MOONEY AIRCRAFT INC.  
KERRVILLE, TEXAS

SERVICE LETTER 20-24

SERVICE BULLETIN M.20-24

SUBJECT: Kit-Improved replacement for P/N 7039 "Shaft assembly  
Nose Gear Steering Horn".

Figure 1  
Looking aft at firewall

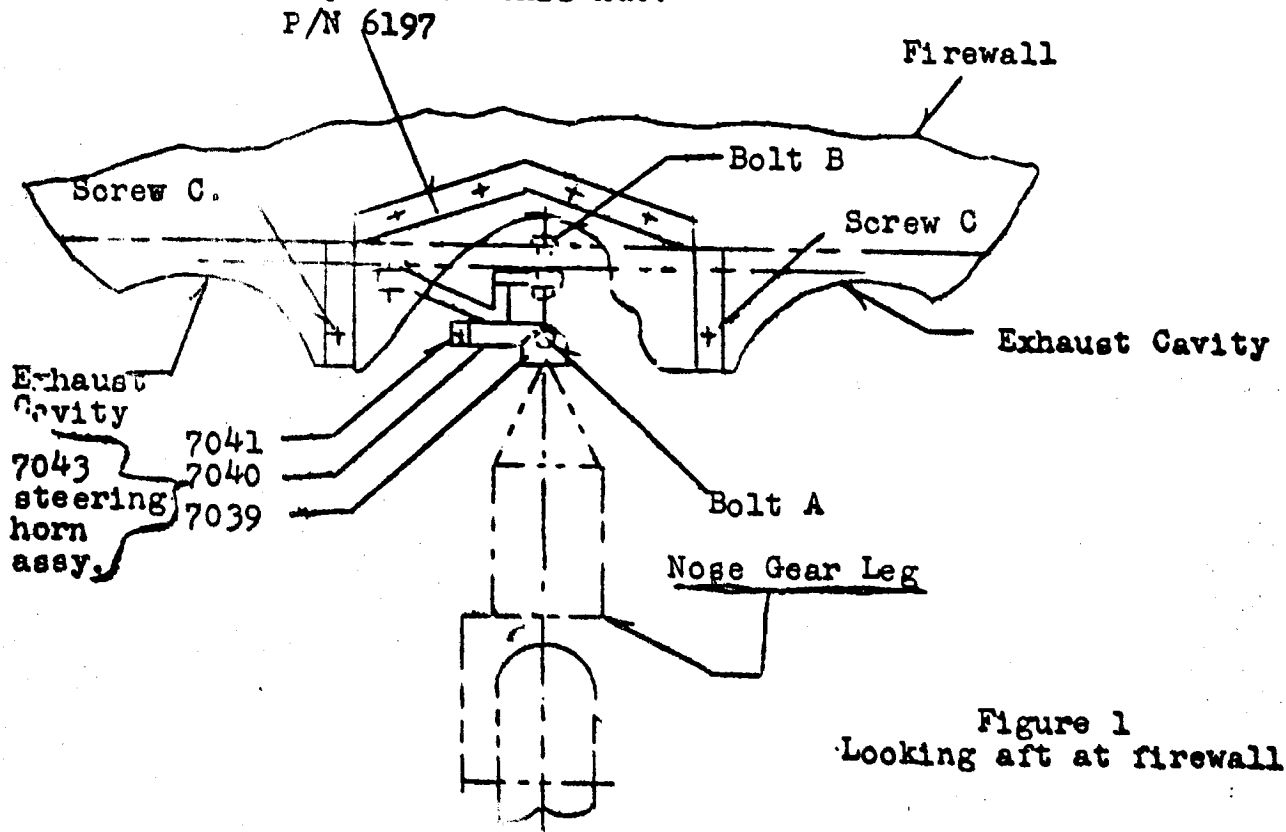
There have been a few instances of failure of P/N 7039 (See figure 1) in which the long shaft separated from the tubular lug attaching it to the nose gear leg. A minor design change has strengthened this joint on the enclosed P/N 7039. To install this part follow the instructions below. (see figure 1).

1. Remove the side cowls.
2. Remove P/N 6197.
3. Remove bolt A and B.
4. P/N 7043 may then be removed from the airplane by detaching the Heim link at the rudder torque tube fittings. Do not change the adjustment of this link.
5. Remove P/N 7041 collar and P/N 7039.
6. Install new P/N 7039 and replace collar. Apply a light grease to the shaft. P/N 7039 should turn freely but should have a minimum of end play. The fit may be adjusted if necessary by filing P/N 7041 or using shims between it and P/N 7040.
7. Reinstall P/N 7043. At bolt A reinstall the hardened bushing from the old assembly, applying a light grease to its external surface. Bolt A should be pulled down tight. Screw C attaching P/N 6197 to the firewall has a loose speed nut behind the firewall access must be gained through partial removal of the exhaust cavities to position this nut.
